Seattle
Design
Commission

APPROVED
MINUTES OF THE MEETING
18 November 2004

18 Nov 2004 Project: **Fire Station 10 Improvements and Service Center**

Phase: Concept Design

Site Plan Showing Four Components of the Project

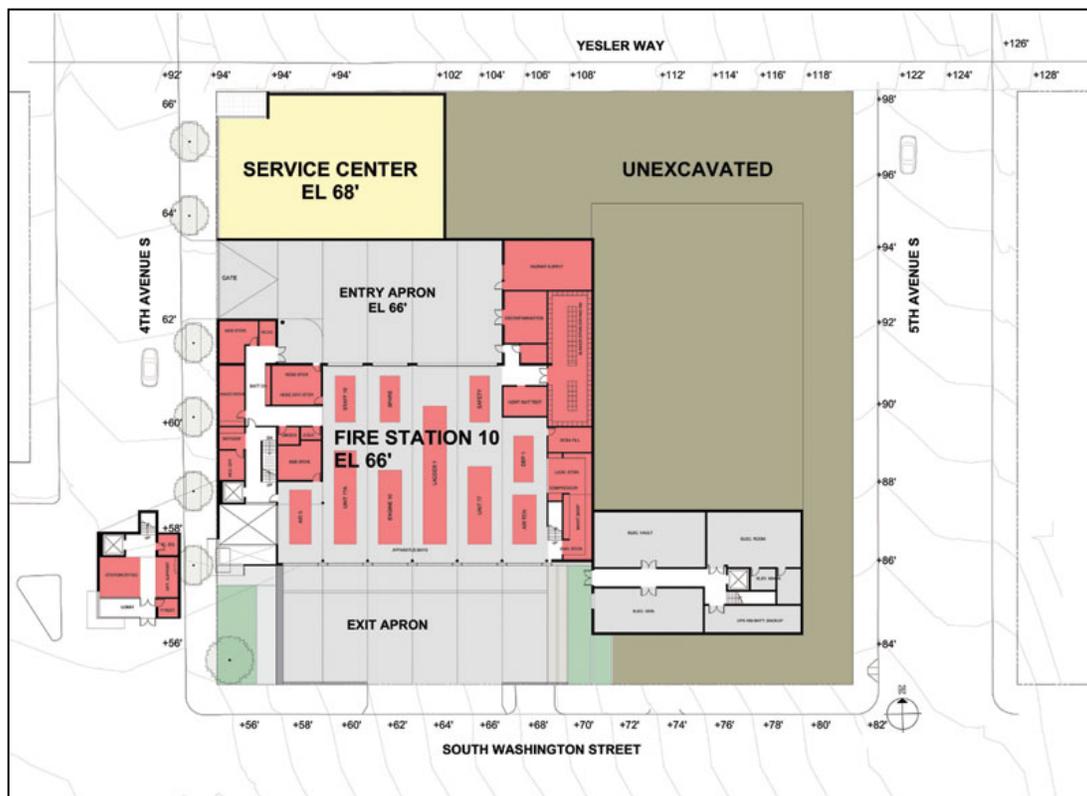
- States that parking needs to accommodate the 35’ easement.
- Asks if there is a LEED target.
 - Proponents stated that the buildings will be certified, but do not achieve Silver status as of yet because it is too much of a challenge on this site. City policy, however, encourages the Silver rating.

- Asks if there are options for the Service Center
 - Proponents stated that the site plan is being designed with alternatives in mind where the Center is located at the northwest edge.

- States that proponents may not need to reinforce the edge of 4th Avenue. Encourages proponents to look at more setbacks and greener options.
- States that this site does not seem like an “urban” site.

- Appreciates the fire truck “stage set” idea.
- Encourages proponents to make the landscape as urban as possible, pulling the building up to the street edge. States that rooftop gardens will be key.

Exterior Perspective of Shelterhouse

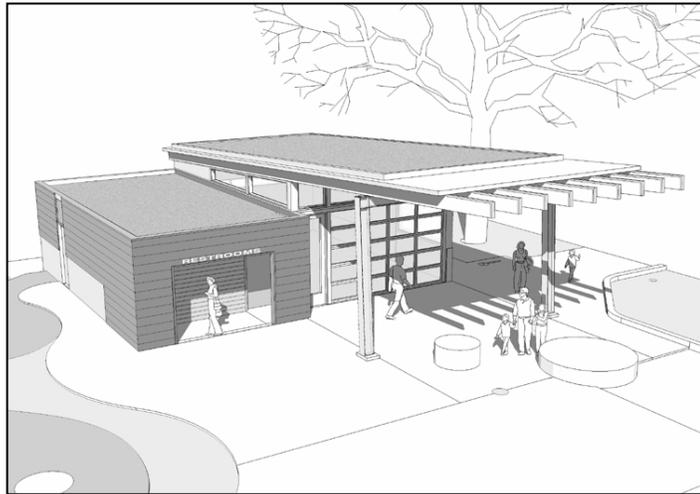
- **Asks that proponents consider increasing the slope of the green roof, or lifting the entire roof for more impact. This will also increase the direct sunlight that reaches the interior space;**

- Feels that there may be some opportunities for interesting architectural expression in terms of the supporting posts of the canopy, such as those used in Olympic College. Such expression may establish the shelterhouse as a community icon.

- Commends proponents on the new design, the organization, and the way the community's concerns have been addressed.
- States that the restrooms and the meeting space are receiving the same sort of attention in terms of massing. Suggests that there may be a way to downplay the massing of the bathrooms, and to add a greater element of safety. States that the restroom massing seems to overpower the massing of the transparent meeting space.

- Suggests that proponents raise the roof a bit more. States that it would be easy to manipulate since the green roof will not be providing a substantial amount of heat for the structure.

Perspective of Exterior Stairway

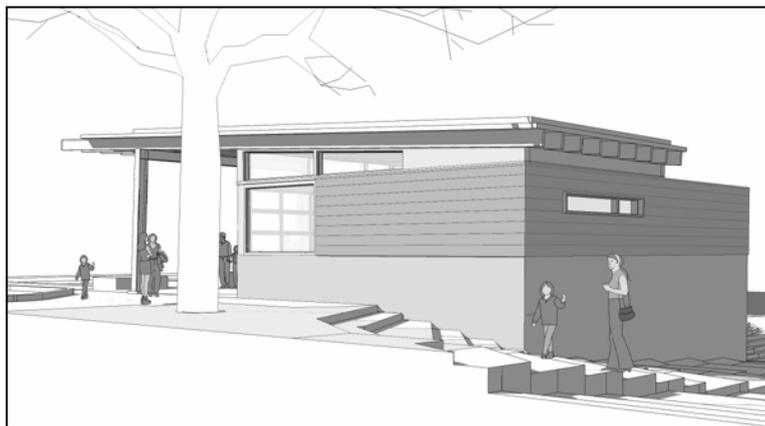
- **Asks that proponents consider channeling rainwater to a rain guard or otherwise explore rainwater harvesting concepts;**
 - **Recommends that site access, especially an improved connection to the northwest corner, be given high priority;**

- States that the cost/value of the project should prioritize the northwest site access path over the green roof.
- States that less canopy might be better. Sun may reach into the space to let more light in.

Schematic Design: Pacific Rim Geographic Collections

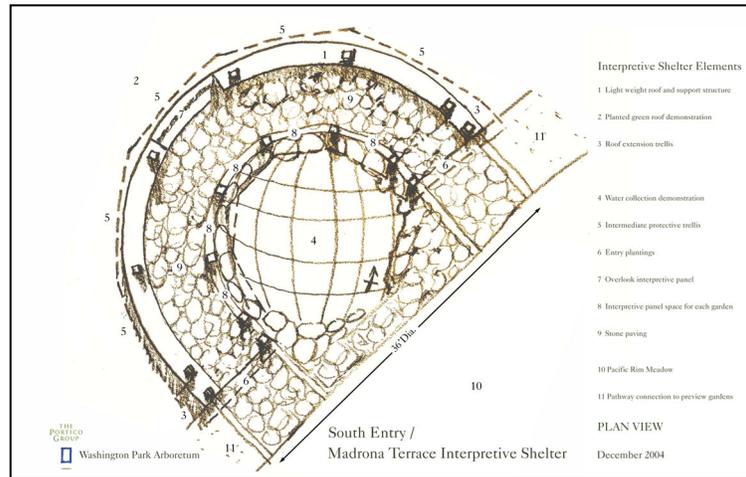
- States that the allocation for the paths is not clear.
- Commends the proponents for an excellent choice of location for the shelterhouse in the meadow clearing.
- Would like to see the existing conditions site plan to assess the proposed improvements and new

- Suggests that the shelterhouse should be more contemporary. Suggests that proponents examine the Tahoma National Cemetery.
- Asks that proponents examine the differences between “bigger and bolder” vs. the Olmsted Plan.
- Encourages proponents to pare down the design.
